SERVICE BULLETIN
Porcia Factory, Italy

COMING OUT OF THE MOTORFAN BELT

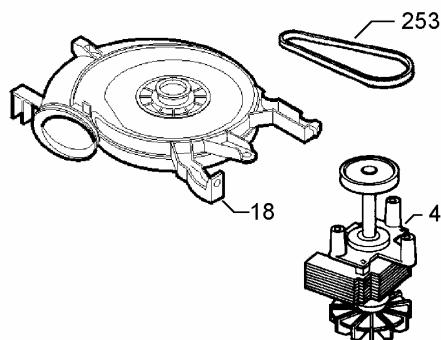
In the appliances produced between the Serial Number 638... and 703... the motor fan belt (253) may come out.

This is due to an incorrect alignment between the fan assembly pulley (18) and the motor fan pulley (4).

To solve this problem, it is necessary to replace the fan assembly (18). The part no. can be found in the Service Notes relative to the appliance and the warehouse will send you the spare part already modified.
